# CITY OF ROCHESTER HILLS OAKLAND COUNTY, MICHIGAN EASTERN AVENUE PARKING LOTS CITY FILE # - X00-000

Site Plan Review		
Reviewed for compliance to the City Ordinance, Building and Fire Codes		
Department	Reviewer	Approved
Planning	Kristen Kapelanski 248-841-2772 KapelanskiK@RochesterHills.org	Yes
Building	Mark Artinian 248-841-2446 ArtinianM@RochesterHills.org	Yes
Engineering	Jason Boughton 248-841-2490 BoughtonJ@RochesterHills.org	Yes
Traffic	Keith Depp 248-841-2503 DeppK@RochesterHills.org	Yes
Nat. Resources	Matt Einheuser 248-841-2551 EinheuserM@RochesterHills.org	Yes
Fire	Lt. Josh Boyce 248-841-2713 BoyceJ@RochesterHills.org	Yes
<b>City of Rochester Hills</b> <b>Planning &amp; Economic Development</b> Conditions and mark-ups noted throughout the plan set must be addressed prior to final approval.

CONTRACT FOR: CONSTRUCTION OF PARKING LOTS AND WALKWAY ALONG EASTERN AVENUE FROM CITY PROPERTIES SOUTH OF THE SOUTH DOWNTOWN ALLEY TO AUBURN ROAD.

CITY OF ROCHESTER HILLS  
EASTERN AVENUE PARKING LOTS  
DEMOLITION PLAN

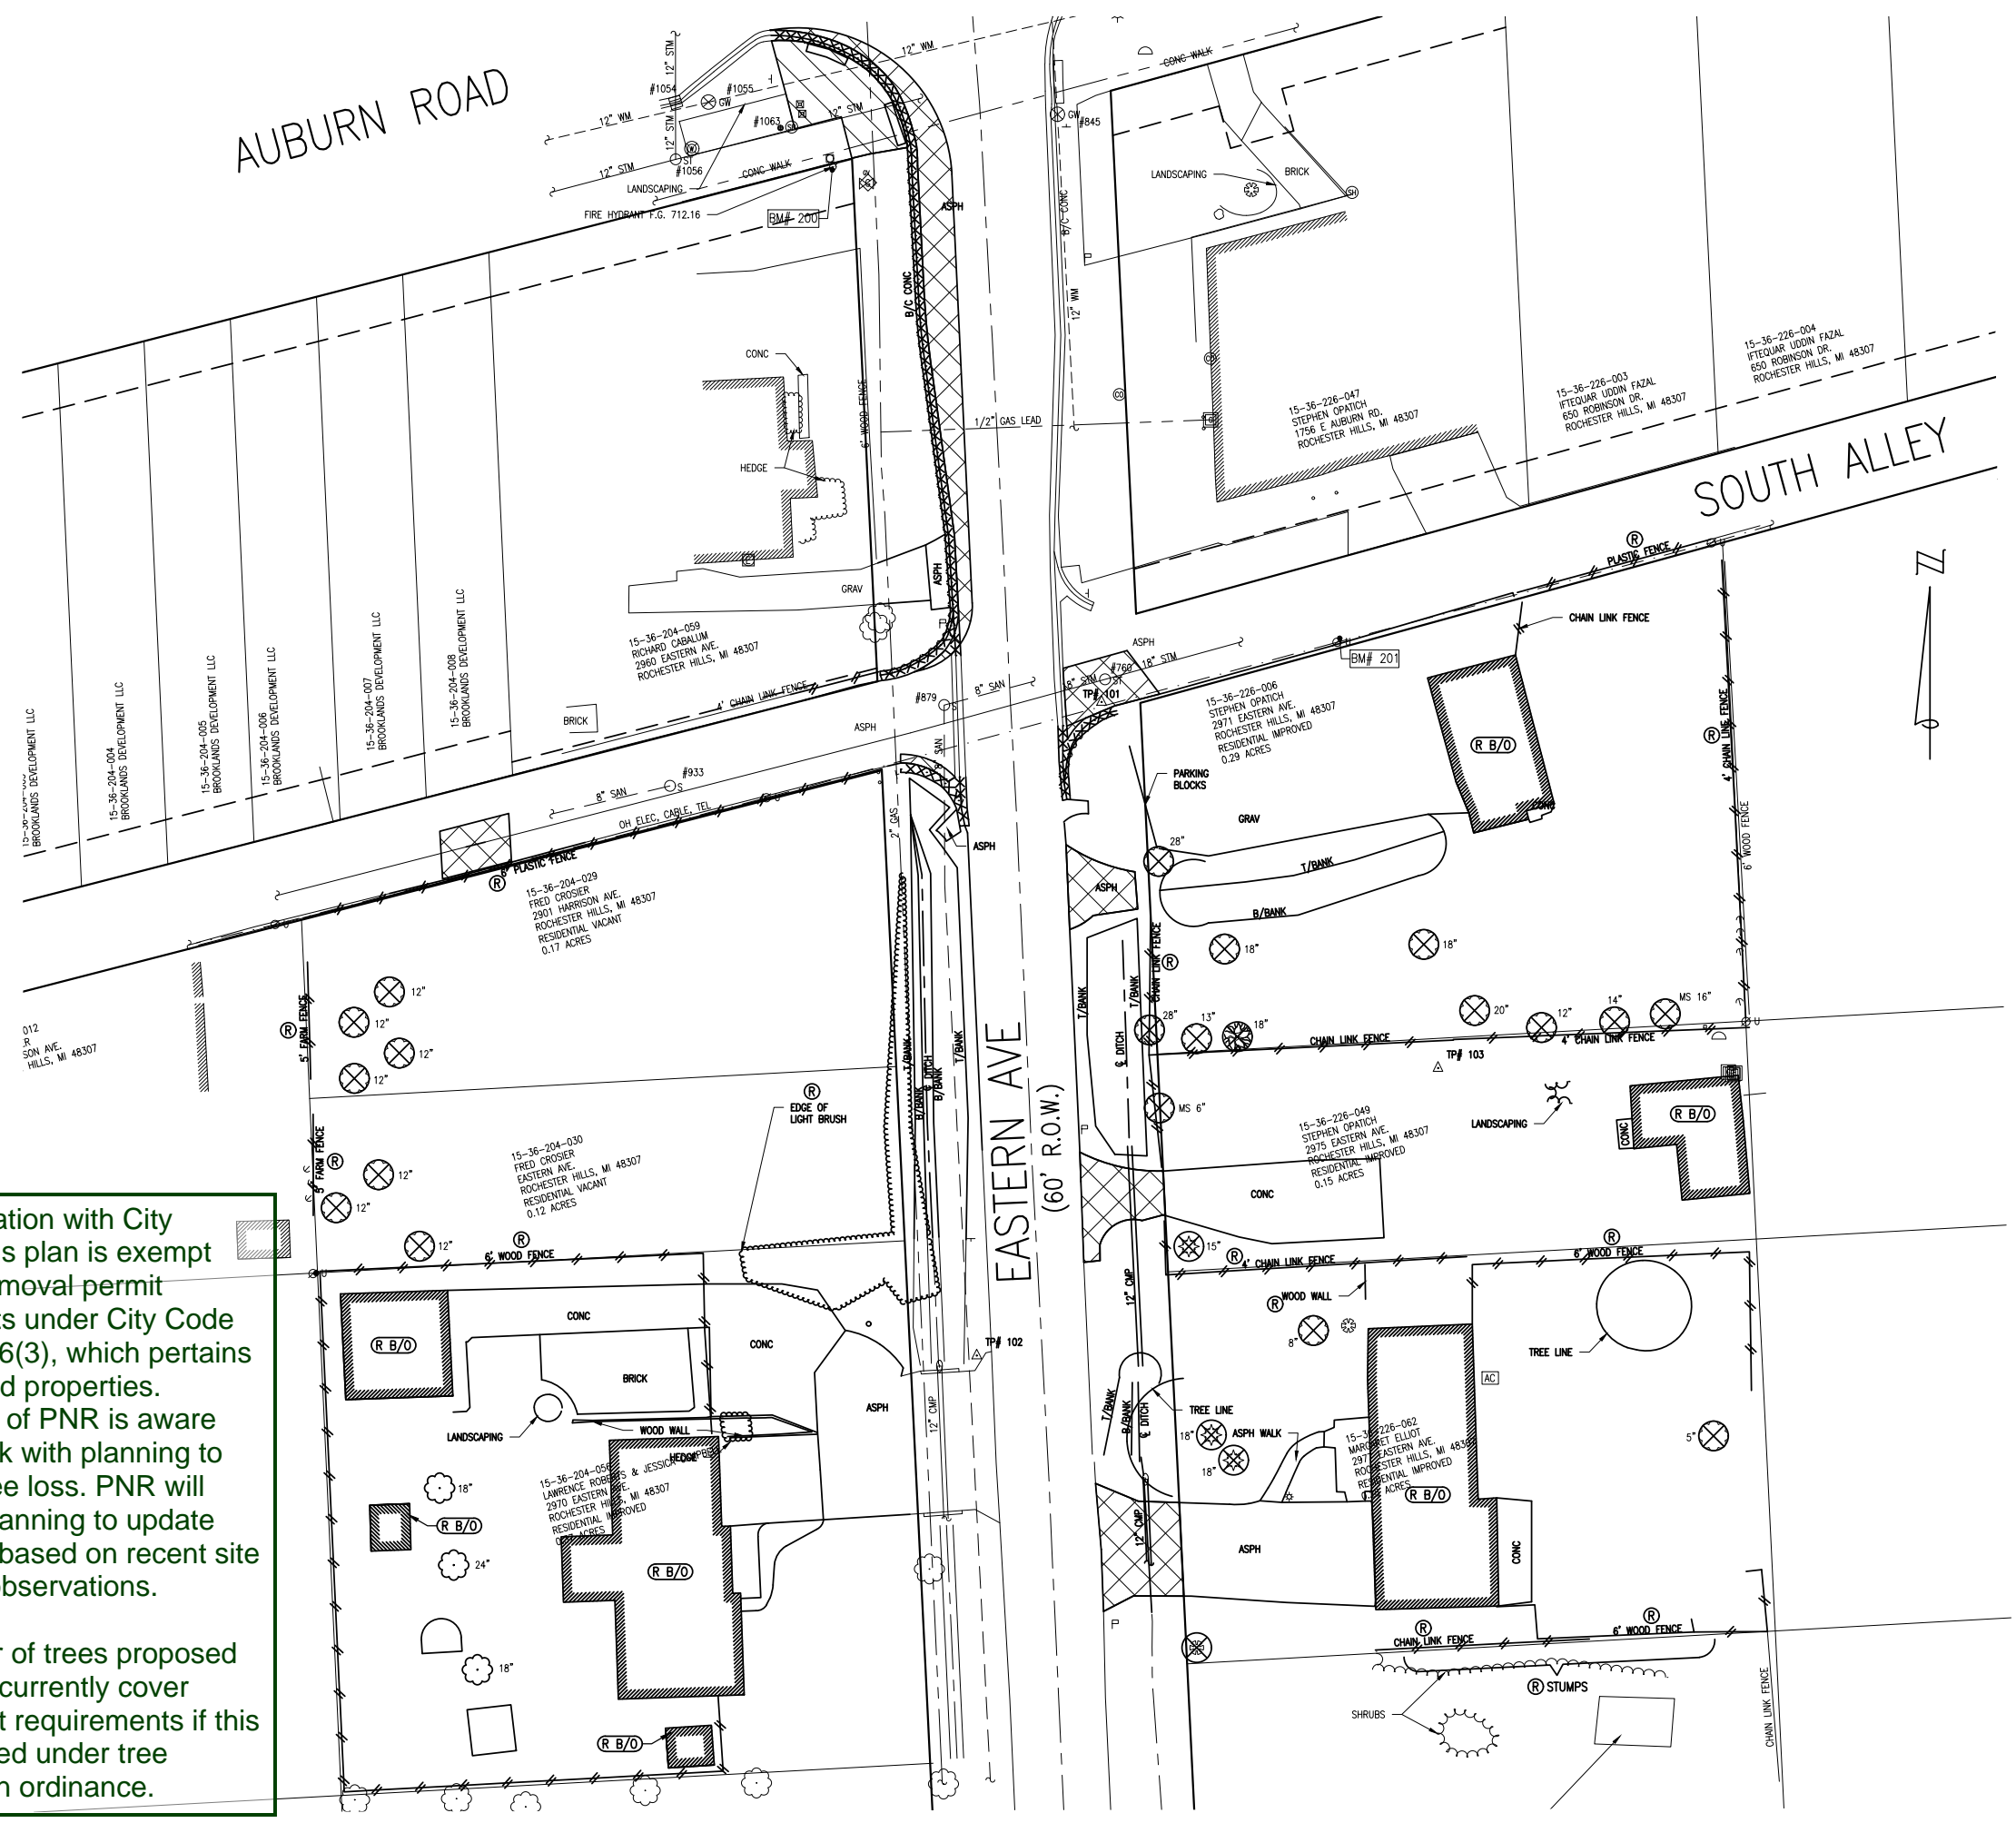
Per consultation with City Attorney; this plan is exempt from tree removal permit requirements under City Code sec. 126-266(3), which pertains to city owned properties. Department of PNR is aware and will work with planning to minimize tree loss. PNR will work with planning to update tree survey based on recent site inspection observations.

The number of trees proposed for planting currently cover replacement requirements if this was regulated under tree conservation ordinance.

Show storm drain easement L.10277 P.876 and L. 10354 P.458

CITY OF ROCHESTER HILLS  
EASTERN AVENUE PARKING LOTS  
LANDSCAPE NOTES

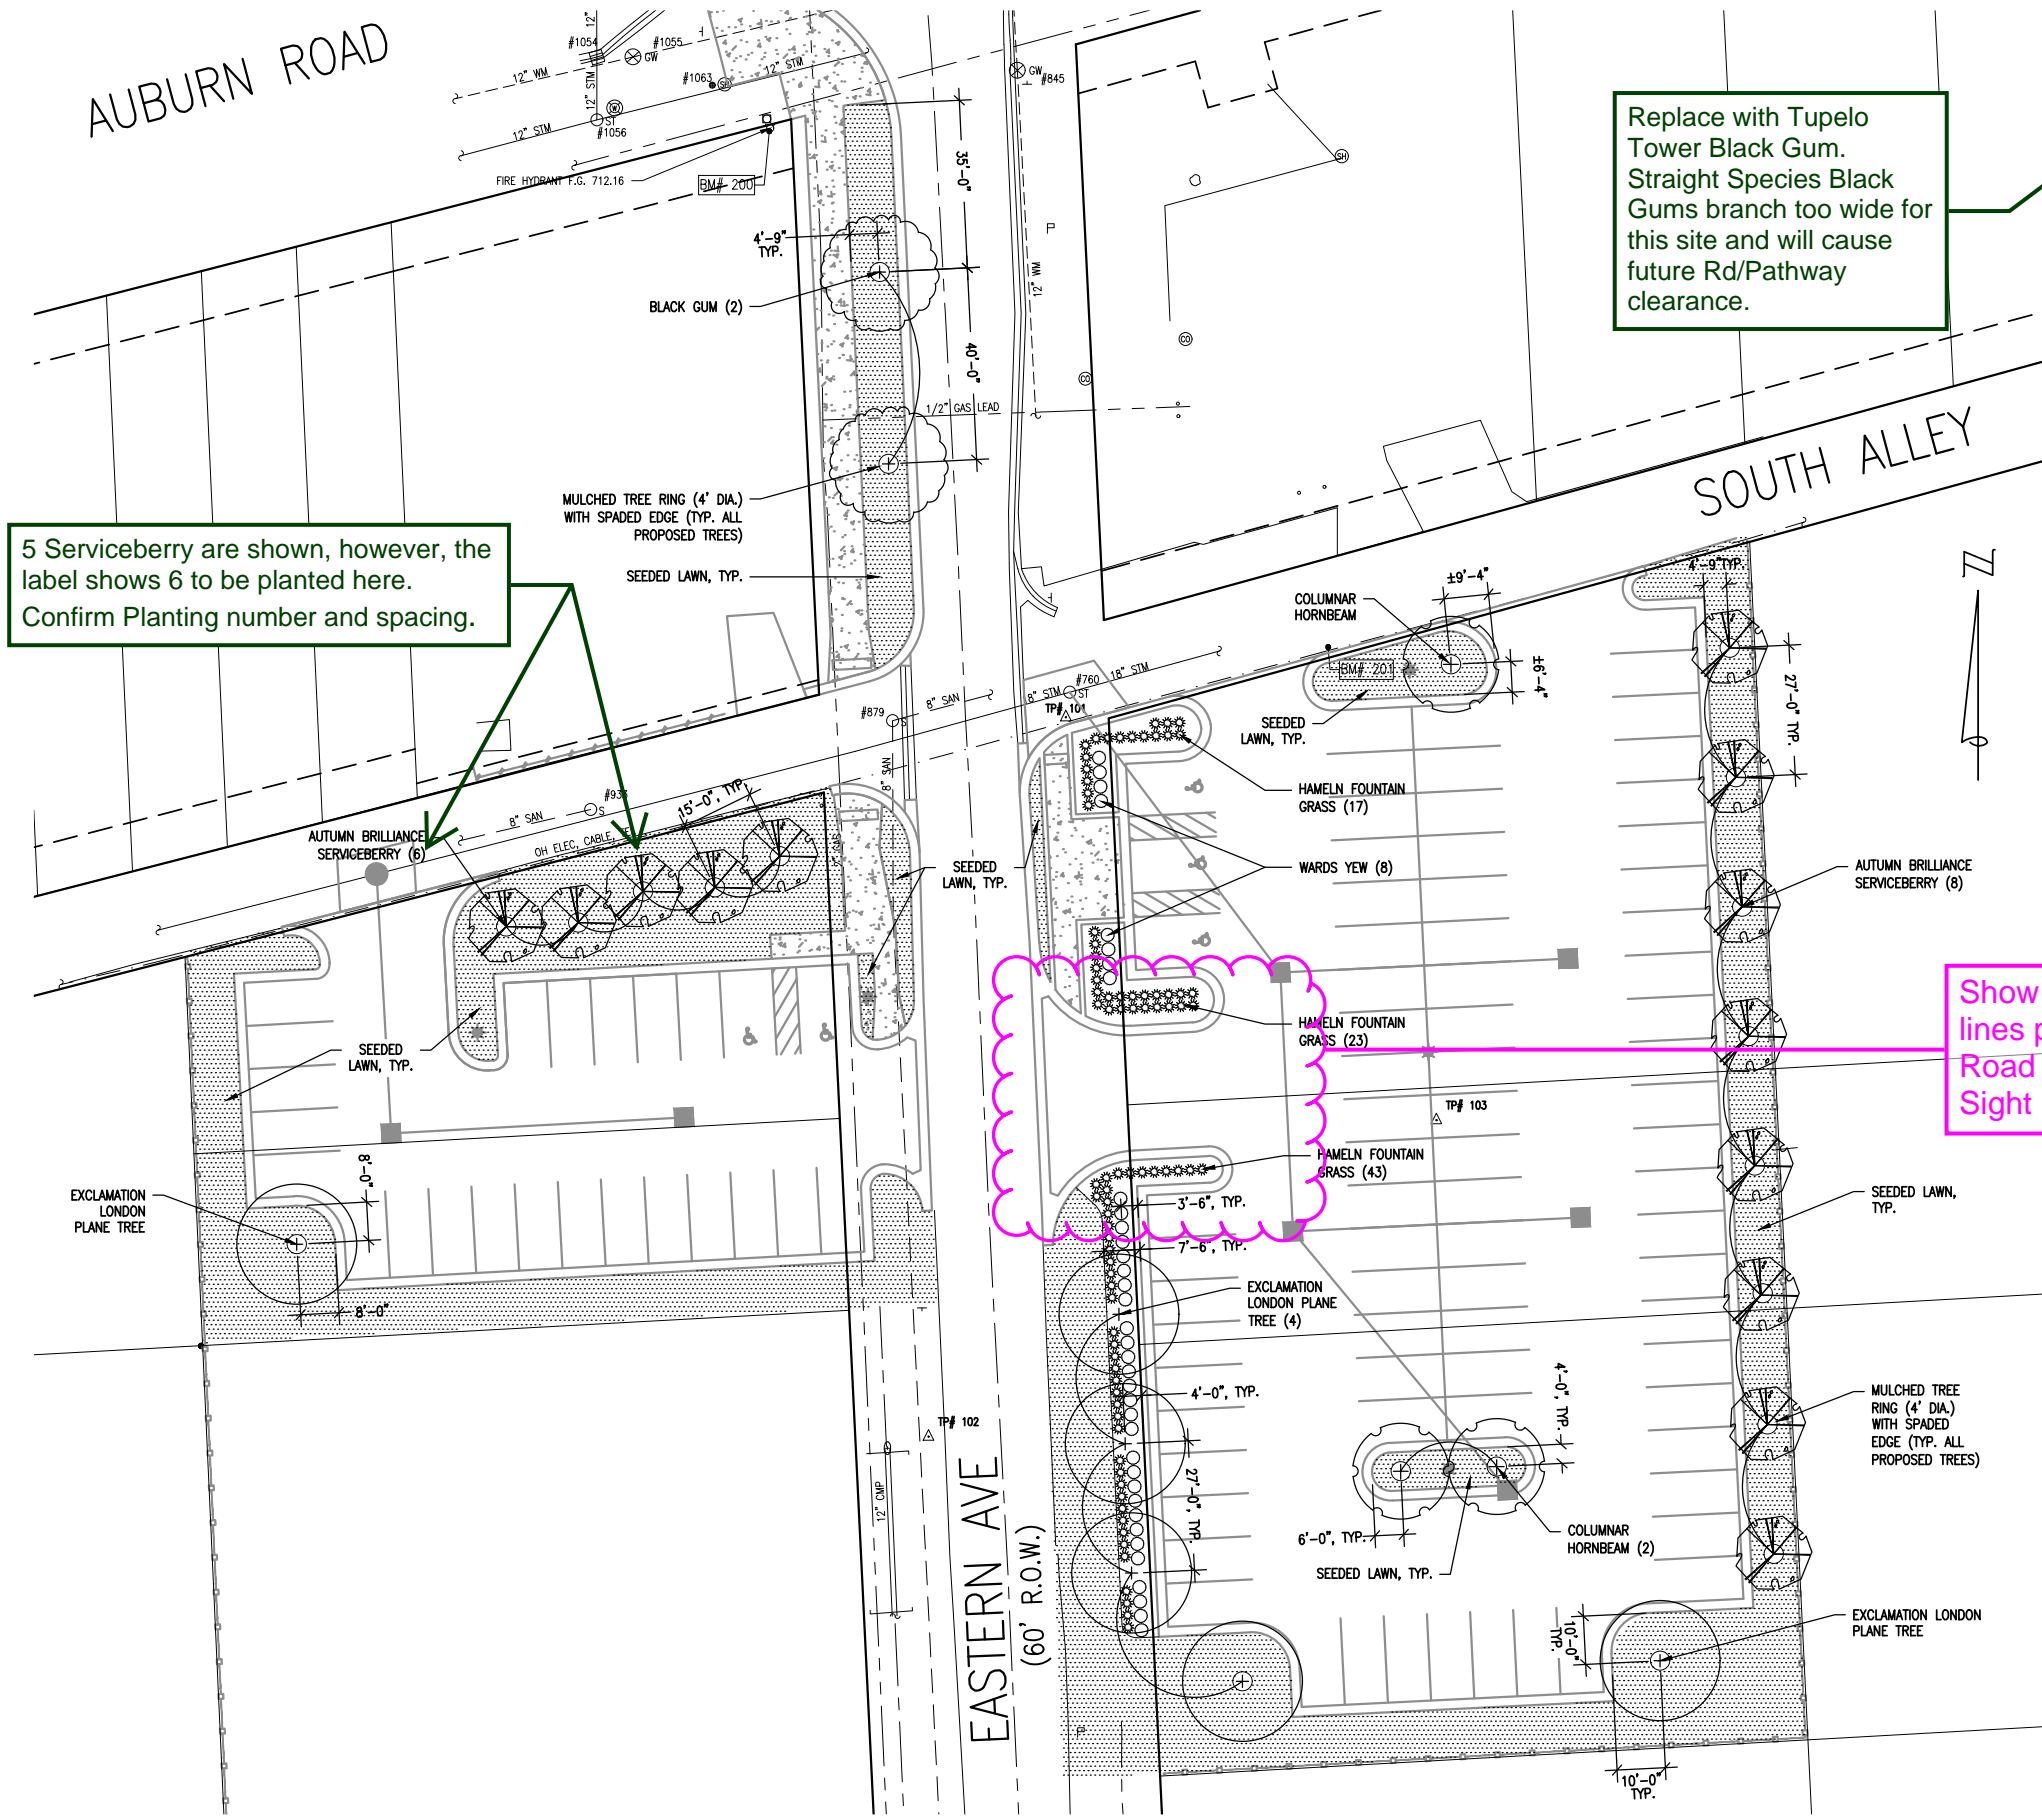
5 Serviceberry are shown, however, the label shows 6 to be planted here. Confirm Planting number and spacing.

Replace with Tupelo Tower Black Gum. Straight Species Black Gums branch too wide for this site and will cause future Rd/Pathway clearance.

Show sight distance lines per the attached Road and Pathway Sight Line Details.
